THE MEADOWS

BESSBOROUGH BLACKROCK CORK

SB-2020-106 THE MEADOWS-POST TRI-PARTY ALTERATIONS REPORT

CRECHE LAYOUT

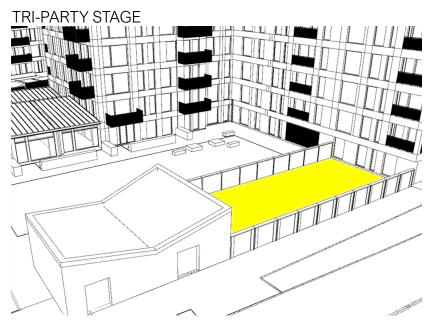
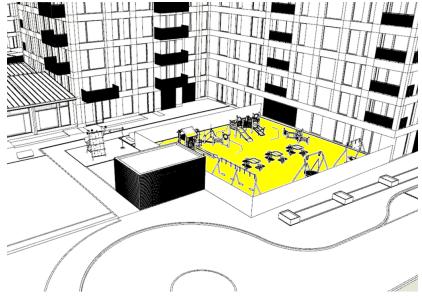
Adjustment to creche layout and creche play area in order to increase capacity from 25 child to 35 children.

CRECHE DROP OFF AREA

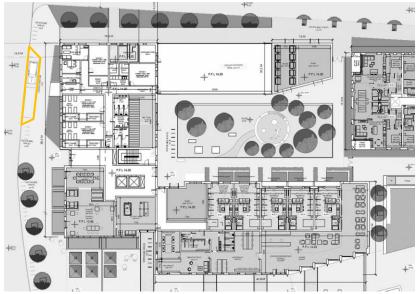
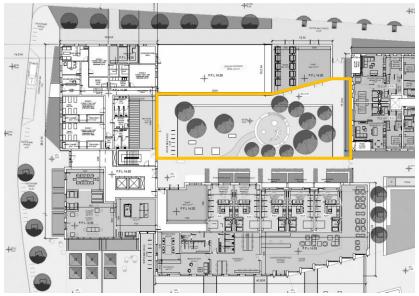
Creche drop off area moved to north with 2 additional spaces added. Vehicle turning bay added to increase efficiency and safety of drop off area and negate the need for turning to the South west corner of the site.

NORTH AMENITY AREA

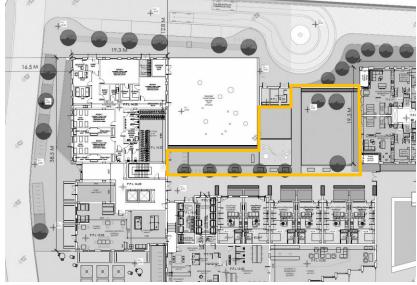
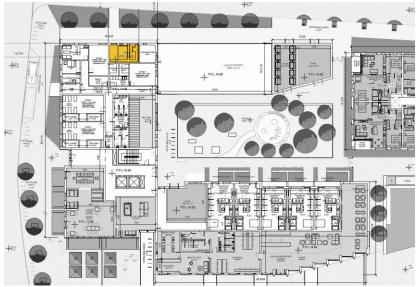
Adjustments made to the Northern amenity area in order to accommodate changes to creche play area and vehicle turning area.

SUBSTATION

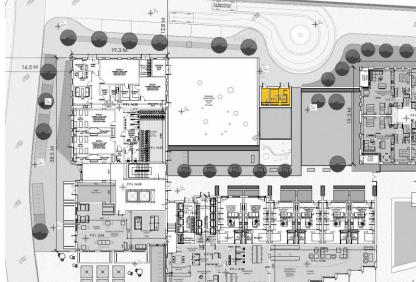
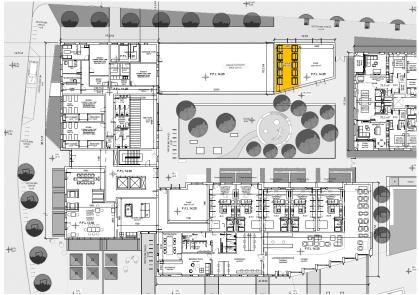
Substation moved in order to accommodate increased capacity of creche.

REFUSE AREA

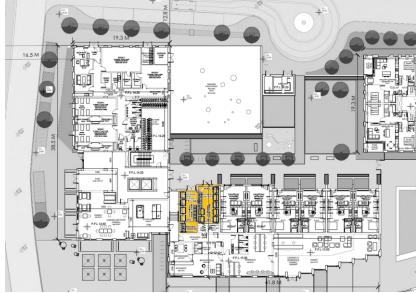
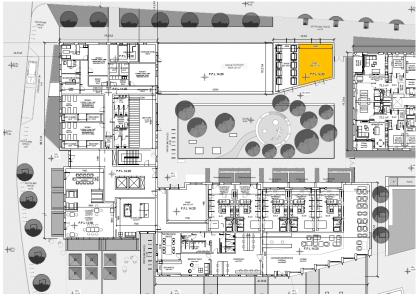
Refuse area moved and increased on detailed review in order to accommodate the new vehicle turning bay.

PLANT ROOM

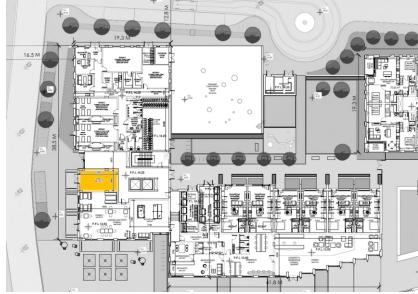
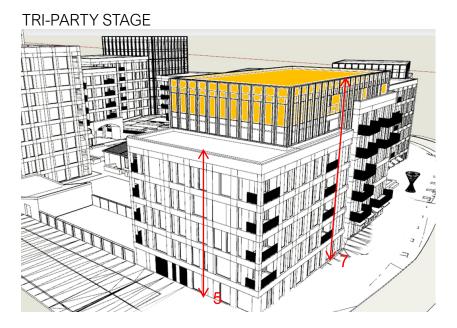
Plant room moved in order to accommodate new vehicle turning bay.

ADDITIONAL STUDIO APARTMENT

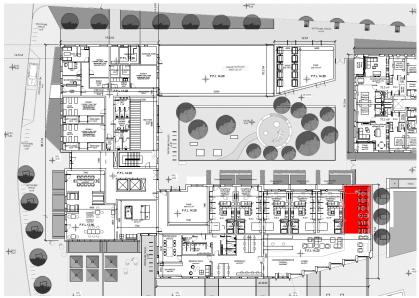
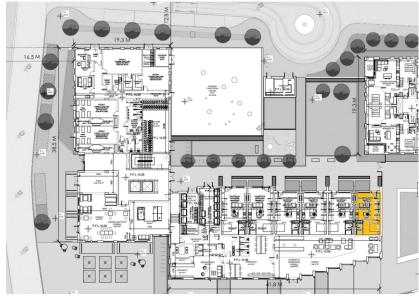
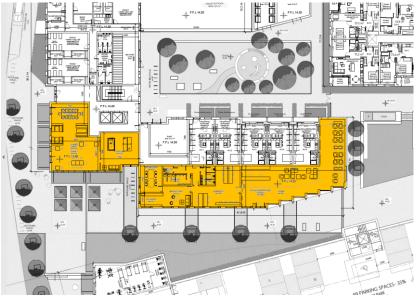
Communal area adjusted in order to accommodate 1 additional studio apartment.
